STAFF RECOMMENDATION
1817 4th Avenue North
June 3, 2013

Application: New construction-addition and Setback reduction
District: Salemtown Neighborhood Conservation Zoning Overlay
Council District: 19
Map and Parcel Number: 08108029000
Applicant: Lynn Taylor, Taylor Made Plans
Project Lead: Robin Zeigler, robin.zeigler@nashville.gov

<p>Description of Project: The applicant proposes a one-story addition that is wider than the existing house and requires a side setback reduction that will be similar to the existing setback.</p> <p>Recommendation Summary: Staff recommends approval with the condition that the applicant obtain administrative approval for windows, doors, gate and brick. With this condition, Staff finds the project to meet the guidelines for an addition in the Salemtown Neighborhood Conservation Zoning Overlay.</p>	<p>Attachments A: Photographs B: Site Plan D: Elevations</p>
---	--

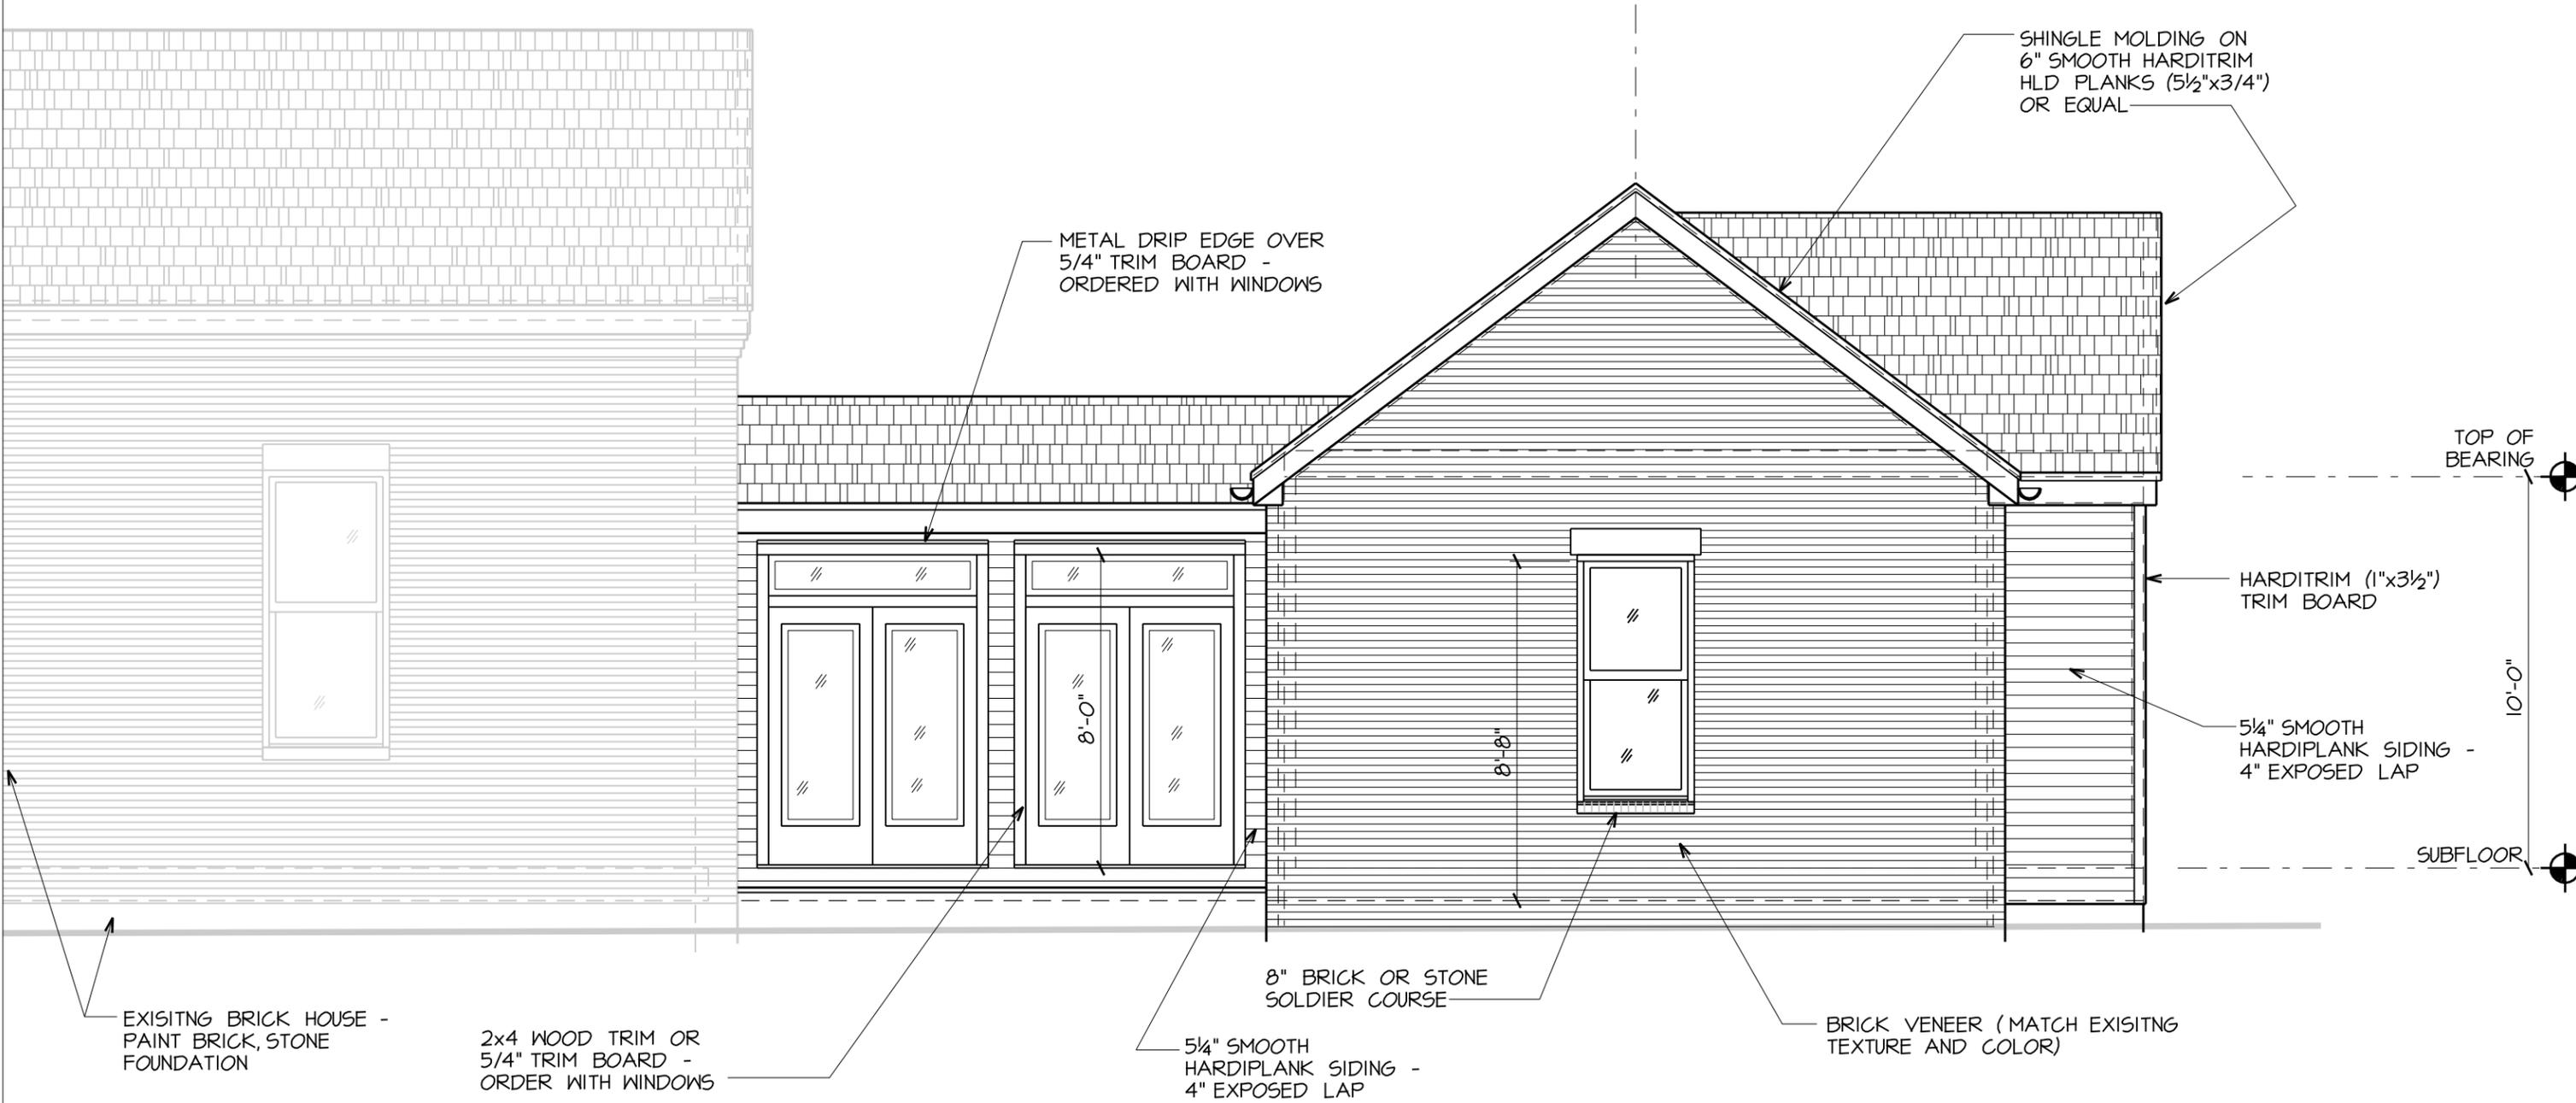
Partial Demolition: The applicant proposes to remove the four windows seen on the left side of the rear addition (see image to right) and replace them with two windows that are more appropriate in proportion to historic windows. Since these windows are not historic partial-demolition is appropriate.

A portion of this addition will be removed for the new side, extended addition. The project meets the design guidelines for demolition as the addition is not historic.

RIGHT SIDE ELEVATION

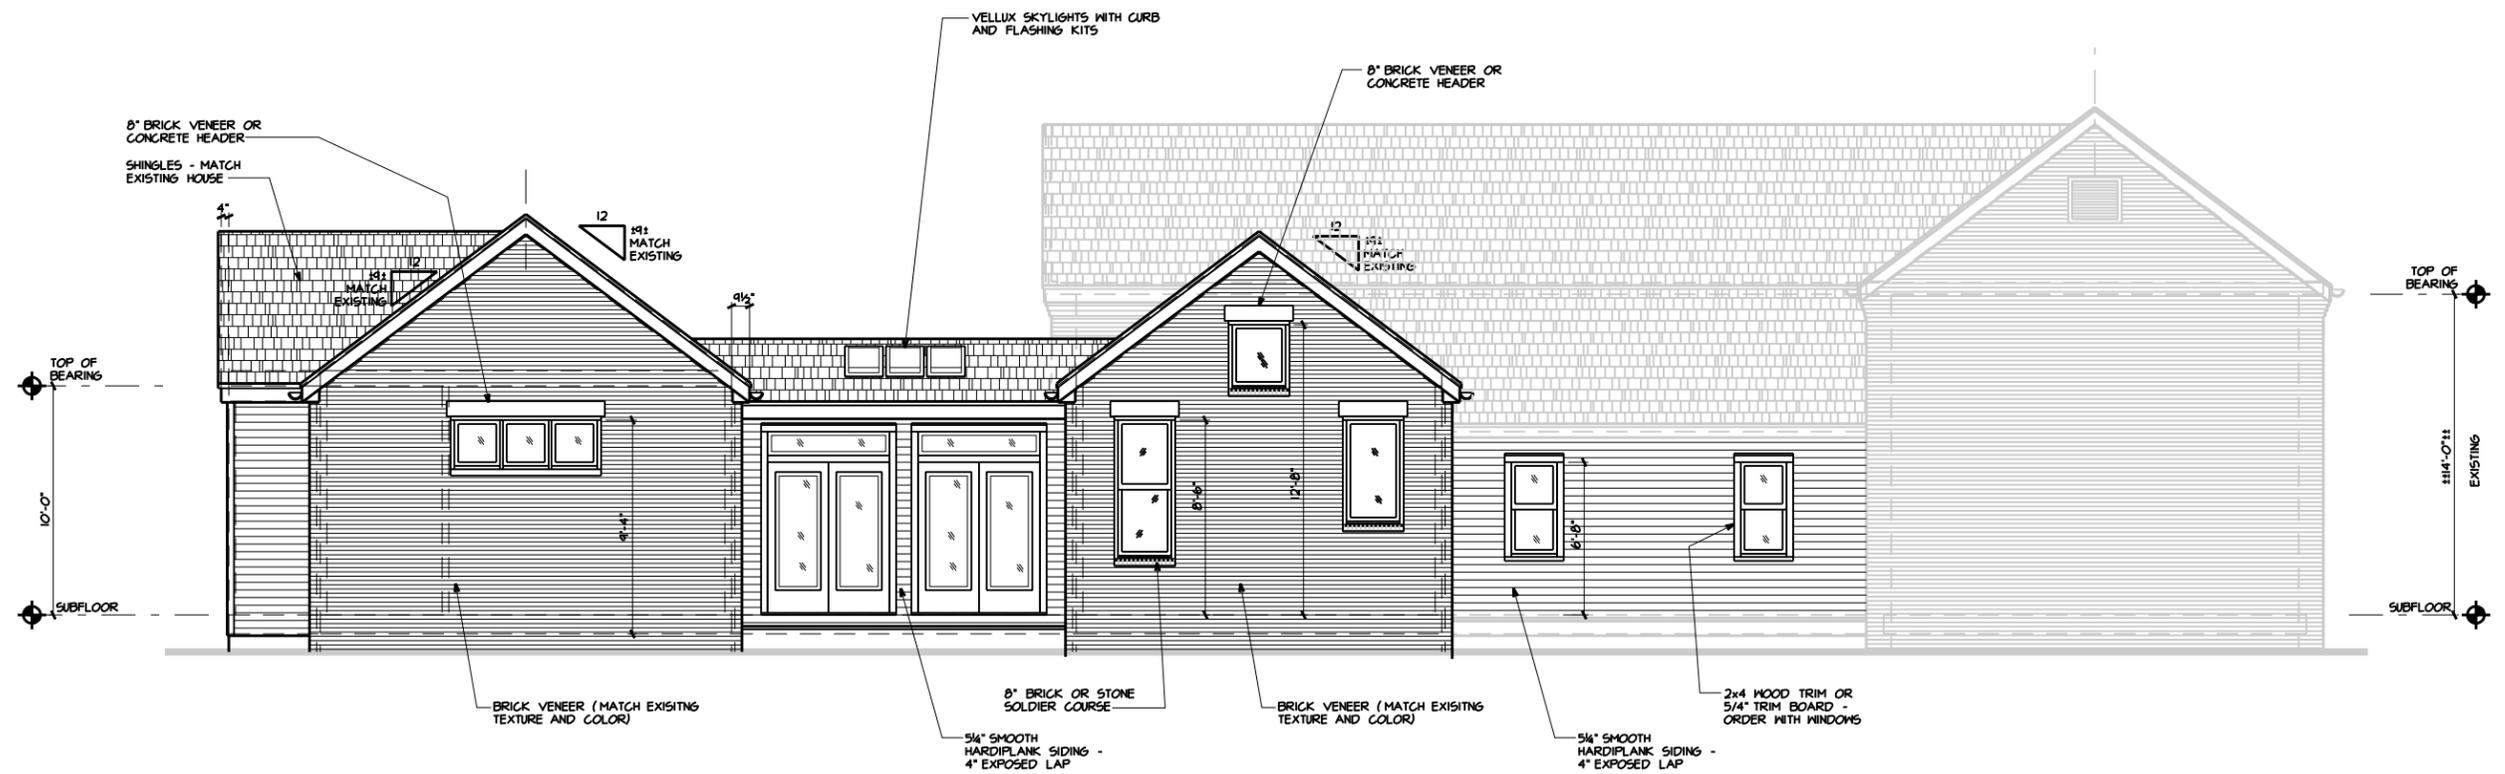
Setback and Rhythm of Spacing: The project meets bulk zoning requirements for the rear and left side setbacks; however, the right side setback is approximately three feet and

eight inches (3' 8") as opposed to the five feet (5') required by zoning. Staff finds the reduced setback to be appropriate since it is similar to the existing setback of the historic building, which is slightly more than three feet (3' 5 1/4"). The project meets section III.C of the design guidelines.
